# Access Compliance Report

## Public Rights-of-Way

### (Curb Ramps)

Intersection ID: 20542	Main Street: MORNING_MIST_LN	Cross Street: STEELECHASE_DR	Location: NW
ADA ID: BFDEE6723D44	Ramp Type: Perp	Initial Pass/Fail: Fail	Overall Compliance: No
		Severity Score: 12.5

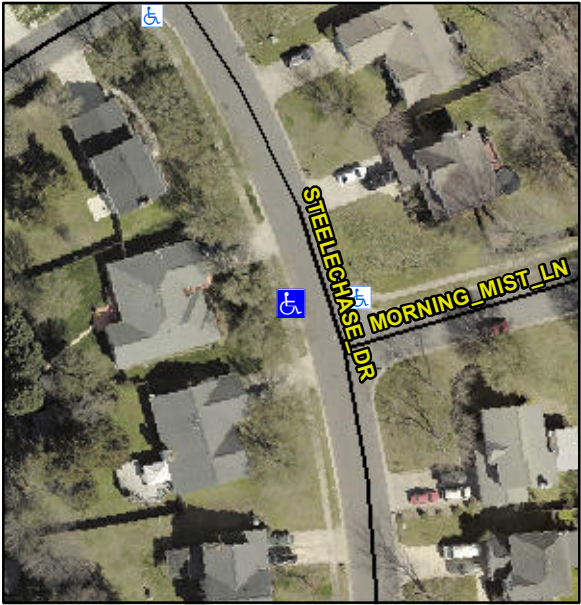
Codes/Mitigation Info/Possible Solution			Field Measurements/Component Compliance		
	Possible Solutions:		<b>Compliance</b>	<b>Description</b>	<b>Data</b>
	<b>Remove &amp; Replace Entire Ramp.</b>		<b>Yes</b>	Ramp Length (in)	97.0
			<b>No</b>	Ramp Width (in)	48.0
			<b>N/A</b>	Flare Type LT	N/A
			<b>N/A</b>	Flare Slope LT (%)	N/A
			<b>N/A</b>	Flare Traversable LT?	N/A
			<b>N/A</b>	Landing Length (in)	N/A
			<b>N/A</b>	Landing Width (in)	N/A
			<b>N/A</b>	Landing Slope (%)	N/A
			<b>N/A</b>	Landing X Slope (%)	N/A
<p>Surveyor Notes:</p> <p><b>N/A</b></p> <p>PROW/ADA:</p> <p><b>Not Found, R304.5.3</b></p>			<b>N/A</b>	Flare Type RT	N/A
			<b>N/A</b>	Flare Slope RT (%)	N/A
			<b>N/A</b>	Flare Traversable RT?	N/A
			<b>N/A</b>	DWS Provided?	N/A
			<b>N/A</b>	DWS Contrast?	N/A
			<b>N/A</b>	DWS Length (in)	N/A
			<b>N/A</b>	DWS Full Width?	N/A
			<b>N/A</b>	DWS Offset (in)	N/A
			<b>N/A</b>	Shared Landing?	N/A

<b>N/A</b>	Gutter Ponding?	N/A
			<b>N/A</b>	Gutter Lip Ht (in)	N/A
			<b>No</b>	Painted X Walk1?	N/A
				X Walk 1 Direction	To E
			<b>N/A</b>	X Walk 1 Width (in)	N/A
			<b>4.4</b>	X Walk 1 Slope (%)	N/A
			<b>4.7</b>	X Walk 1 X Slope (%)	N/A
			<b>N/A</b>	Ramp inside XWalk1?	N/A
			<b>N/A</b>	Road Slope (%)	N/A
			<b>N/A</b>	Road X Slope (%)	N/A
			<b>N/A</b>	Any Obstructions?	N/A
				Obstruction Type	
			<b>N/A</b>		
			<b>N/A</b>		
			<b>N/A</b>		
			<b>N/A</b>		
			<b>N/A</b>		
			<b>N/A</b>		
			<b>N/A</b>		
			<b>N/A</b>		
			<b>N/A</b>		
Total Cost:		\$ 1850.00			
			<b>Yes</b>	Surface Condition? (G/P)	Good
